REF: SUP-6008-18

SUBJECT: Special Use Permit for a gas station and grocery store at 3516 Airport Highway

LANDSCAPE PLAN

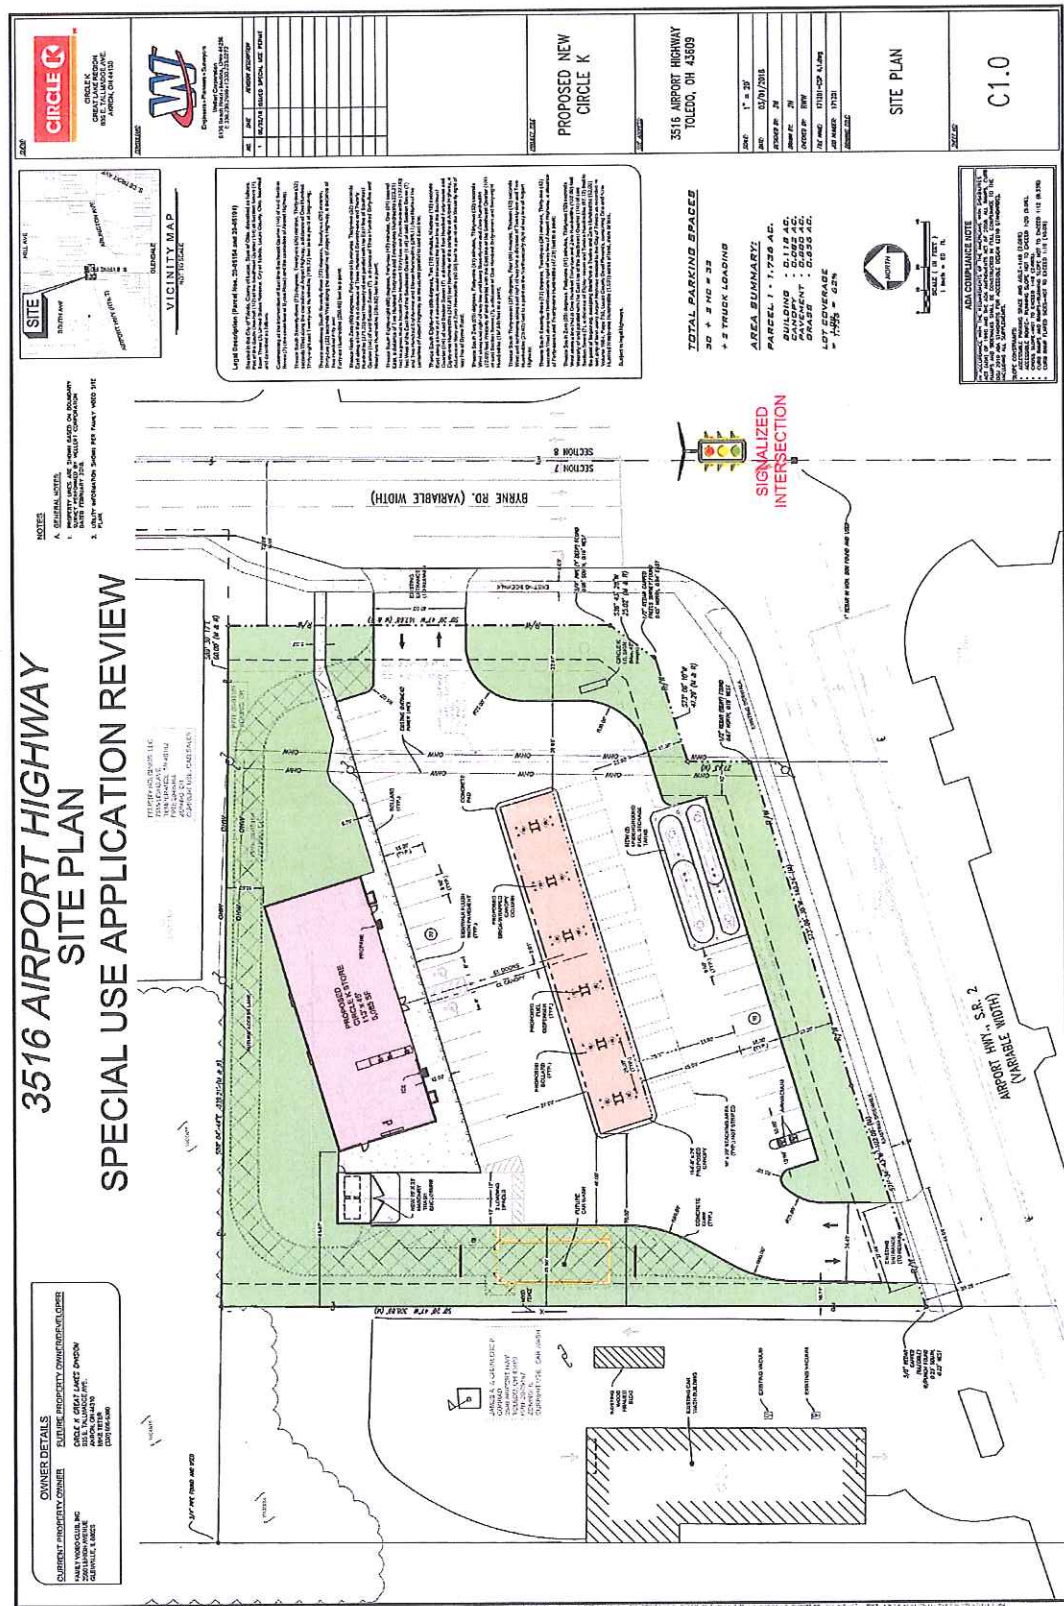
At least one (1) tree must be provided for every thirty (30') feet of lot frontage or fraction thereof. Trees are not required to be evenly spaced and may be clustered. The frontage greenbelt along Airport Highway is required to include a solid evergreen hedge planting to screen the parking lot so that no headlights of any vehicles can be seen from the public street. Planting required to meet this section are not permitted to be located in the public right-of-way. Furthermore, foundation plantings are required along all portions of the building that are visible from the public right-of-ways and landscaping at all major building entrances. A landscape plan that shows compliance with these regulations shall be submitted for review and approval.

- a. A fifteen (15') foot wide greenbelt is required along the South Byrne Road and Airport Highway frontages and must be out of the right-of-way. Calculations conclude that a total of ten (10) trees are required in the frontage greenbelt along South Byrne Road and seven (7) trees are required along Airport Highway. Trees are not required to be evenly spaced and may be clustered. **(The number and species of trees are not acceptable as submitted on the landscape plan. A revised landscape plan shall be submitted showing compliance);**

- d. Foundation plantings shall be added at the main building's entrance. **(Not acceptable as shown on the landscape plan. A revised landscape plan shall be submitted showing compliance);**

Circle K Toledo
EXTERIOR ELEVATIONS

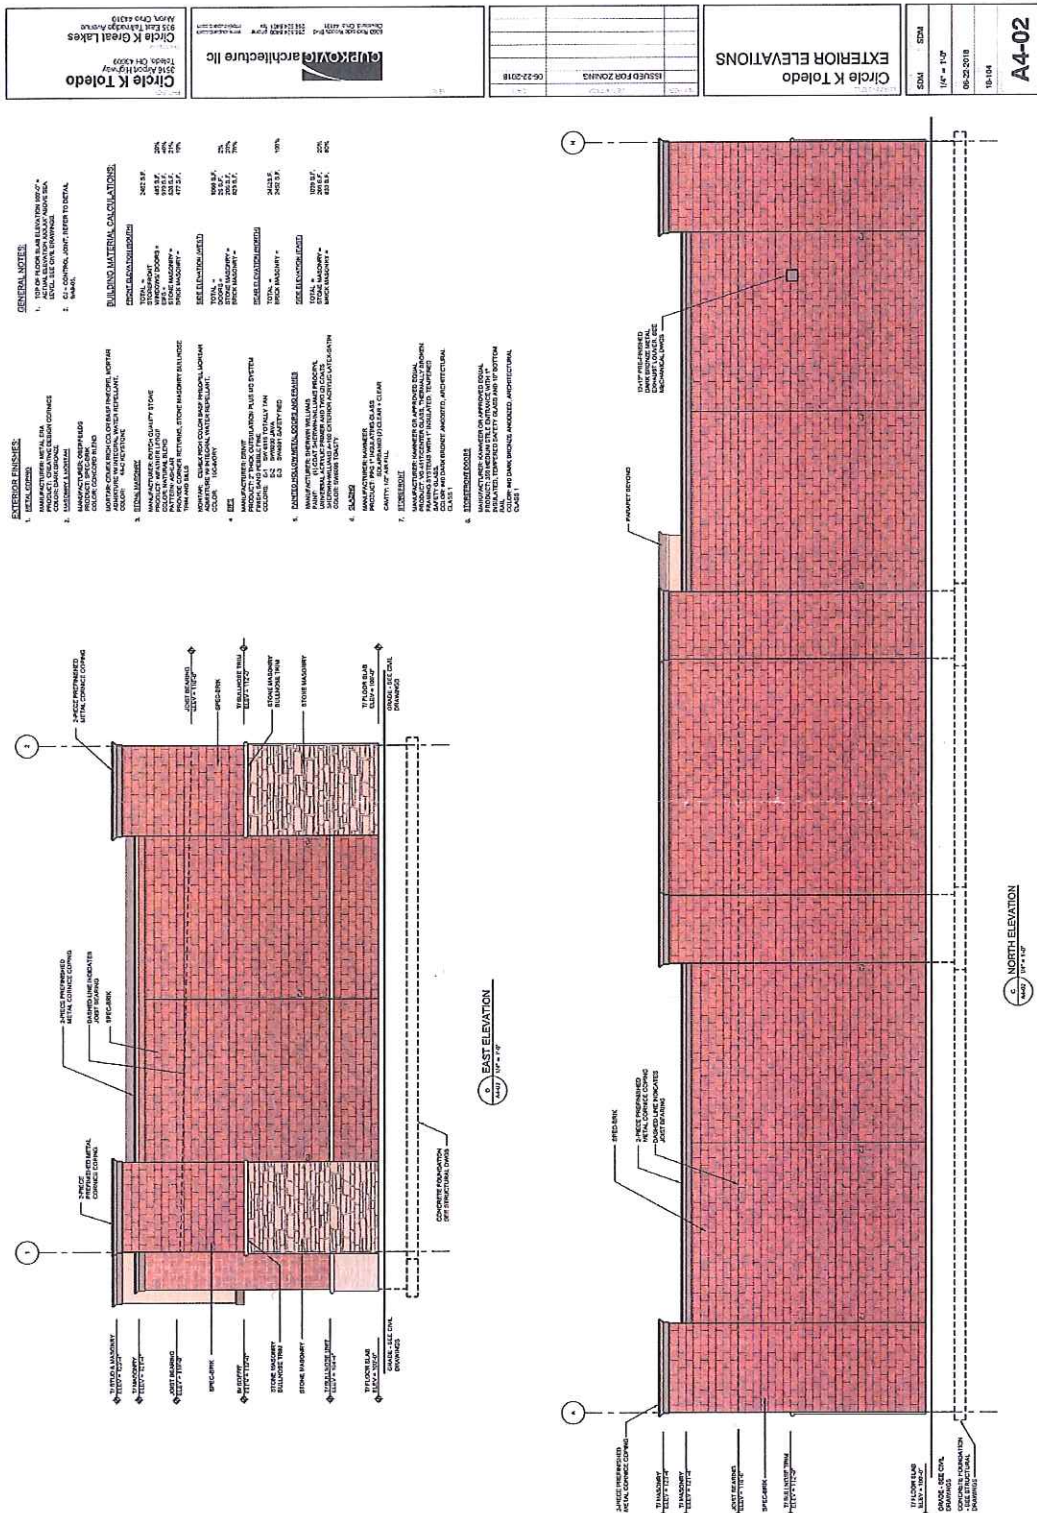
Primary façade materials consist primarily of stone masonry, brick masonry, and E.I.F.S. Pursuant to TMC§1109.0501.6 – *Façade Materials*, exterior insulation and finish systems (E.I.F.S) or equivalent product is only acceptable when thirty-six (36") inches above grade and not within an entryway, and comprising less than fifteen (15%) percent of the façade. The south elevation utilizes forty (40%) E.I.F.S and is not in compliance with the Toledo Municipal Code. The brick masonry is acceptable however, the installation shall be of ½ course founders brick. Furthermore, TMC§1109.0502 requires the use of low-reflectance, subtle, neutral or earth tone materials throughout the development. The bright red accents on the building's facades and on the bollards located in front of the building are not in compliance.

49. Canopies shall be set back a minimum of 10 feet from the property line, and shall be designed to be consistent with the building materials and colors of the principal building. Support columns shall be brick, brick base, or other durable materials compatible with the principle building. The Planning Director may require a peaked roof to complement the principle building (TMC§1104.0903.A). Elevations depict the use of "spec brick" on the canopy columns and building facades. **(Revised elevations depicting ½ course founders brick shall be submitted).**

50. Elevations that depict the use of ½ course founders brick on the building shall be submitted for review and approval.
51. Primary façade materials consist primarily of stone masonry, brick masonry, and E.I.F.S. Pursuant to TMC§1109.0501.6 – Façade Materials, exterior insulation and finish systems (E.I. F. S) or equivalent product is only acceptable when thirty-six (36") inches above grade and not within an entryway, and comprising less than fifteen (15%) percent of the façade. The south elevation utilizes forty (40%) E.I.F.S. **(Not acceptable as depicted on elevation drawing. Revised elevations shall be submitted that show compliance. Additionally, the revised elevations shall depict the use of ½ course founders brick).**

52. TMC§1109.0502 requires the use of low-reflectance, subtle, neutral or earth tone materials throughout the development. The bright red accents on the building's facades and on the bollards located in front of the building are not in compliance. **(Not acceptable as depicted on conceptual rendering. Revised renderings shall be submitted that show compliance).**
